WHYTES GULLY NEW LANDFILL CELL

Response to Submissions/Preferred Project Report

Submitted to:
NSW Department of Planning and Infrastructure

Report Number. 117625003

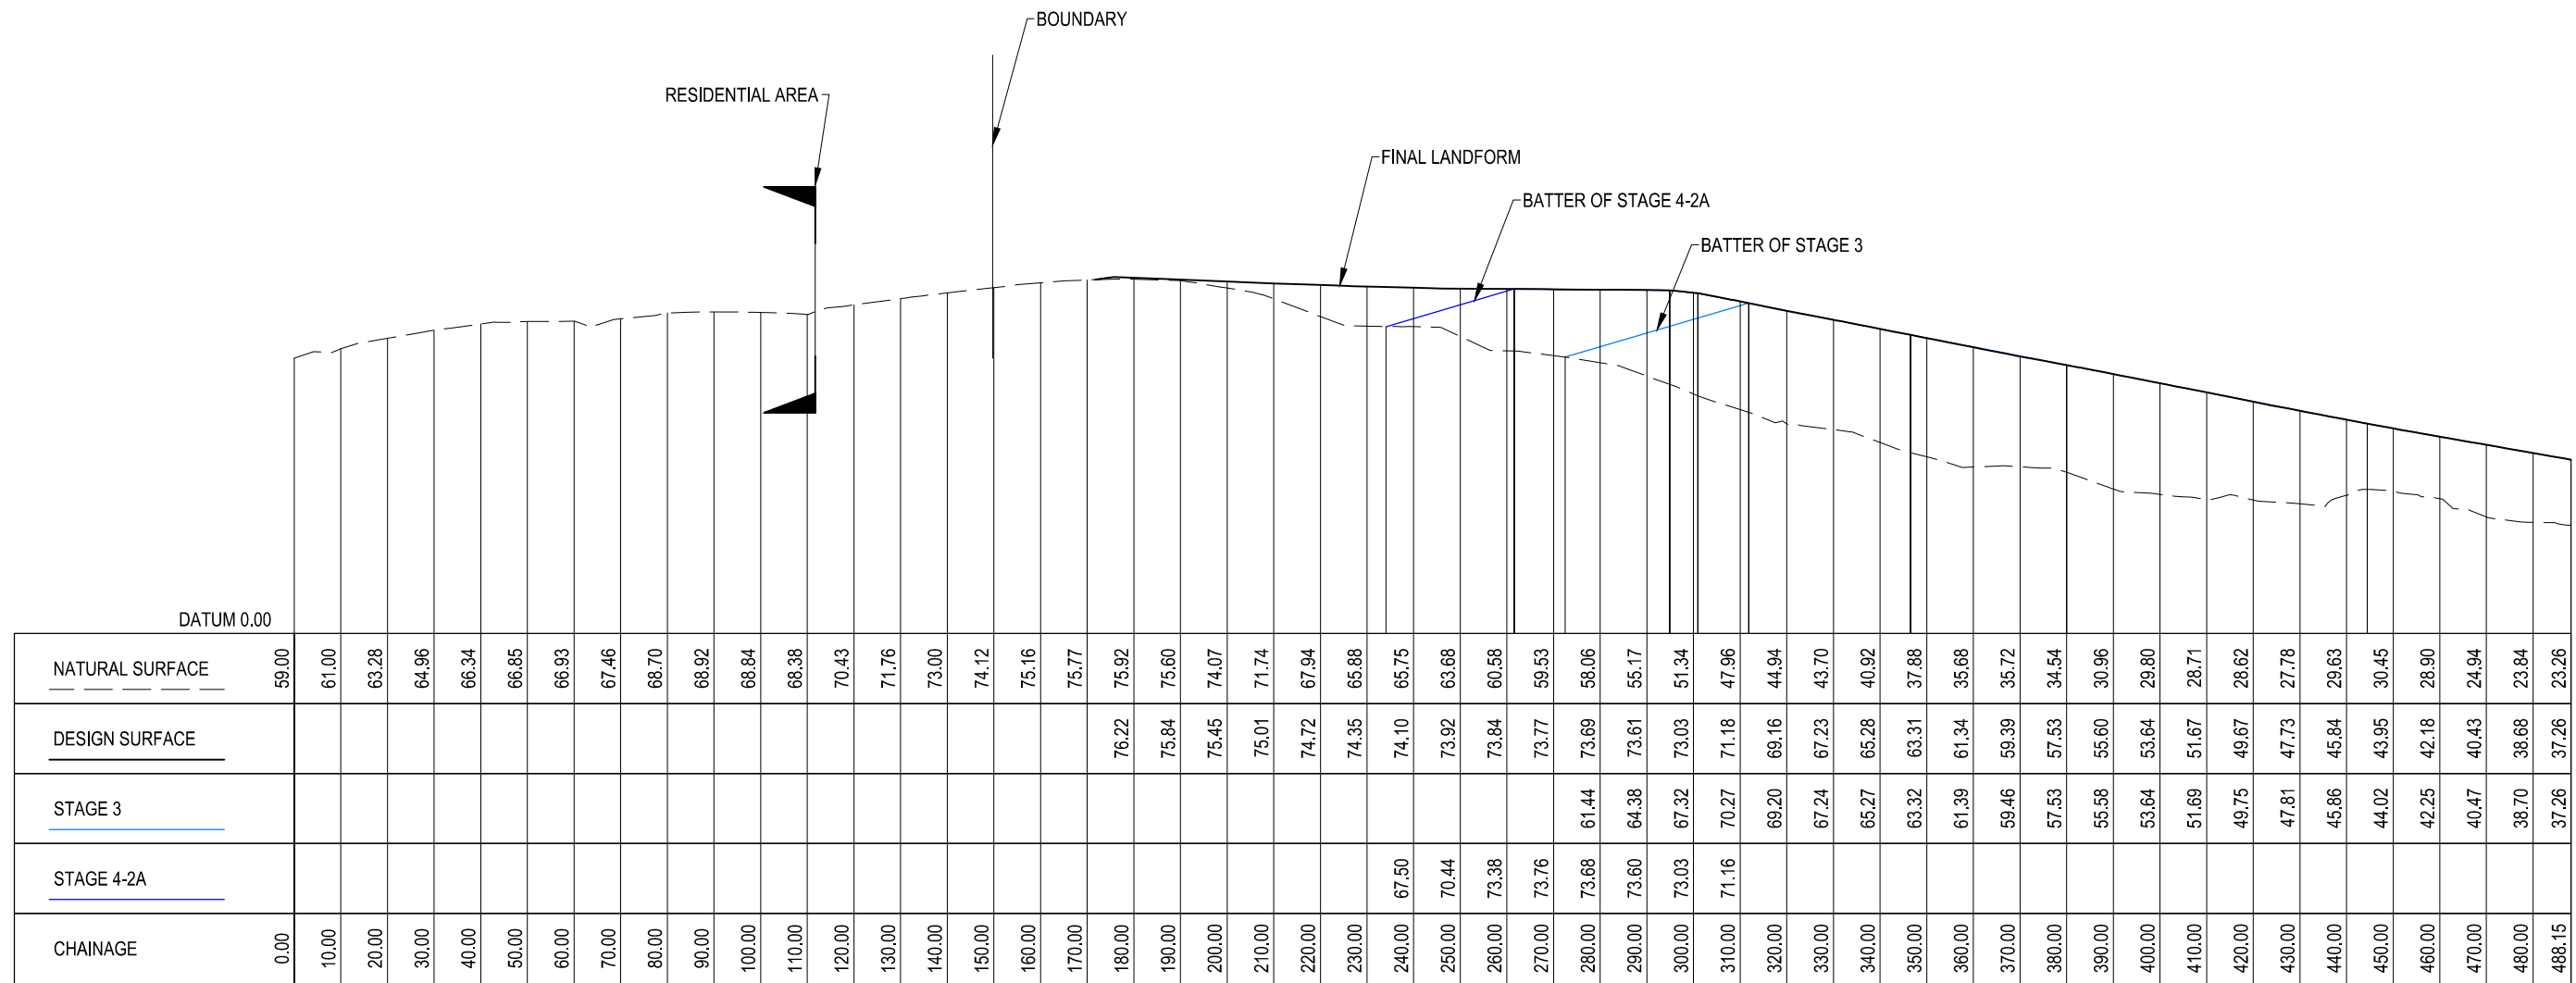
The submission by DPI states the following in relation to noise impacts:

- 2) *The EPA has recommended noise limits for receivers N3 to N5 based on the predicted cumulative noise levels in Tables 15 and 16 in the NIA. Where the levels are more than 2dBA above the PSNLs, the EPA recommends that the proponent implement a noise management plan (NMP) to minimize noise from the site over the life of the landfill. The EPA does not and will not approve or endorse a NMP and does not need to review such a plan.*

In response to comments 1, 2 and 3, to further reduce the potential cumulative effects of the construction and operational activities at Receiver N1, the final Stage (4-2) of the Project has been broken into two parts (Stage 4-2A and Stage 4-2B) (refer Figure 1). Stage 4-2B would be the final stage of the Project to be constructed. The division of the stages as shown in Figure 1 is such that all activity up to and including Stage 4-2A occurs behind the existing north-east ridgeline, and at a greater distance from Receiver N1 than for Stage 4-2B (refer Figures 2). It is proposed that approval of Stage 4-2B would be conditional on further noise modelling and assessment of mitigation measures to be conducted prior to construction. This has been reflected in the revised draft Statement of Commitments in Section 5.0 of the Report. Further details of the revised staging including proposed volumes and timelines are provided in Section 4.0 of the Report.

In order to address comments received from DPI principally relating to potential offsite noise impacts (refer Section 3.4 of the Report), the final Stage of the EA (4-2) is proposed to be split into two parts (Stage 4-2A and Stage 4-2B) (Refer Figure 1).
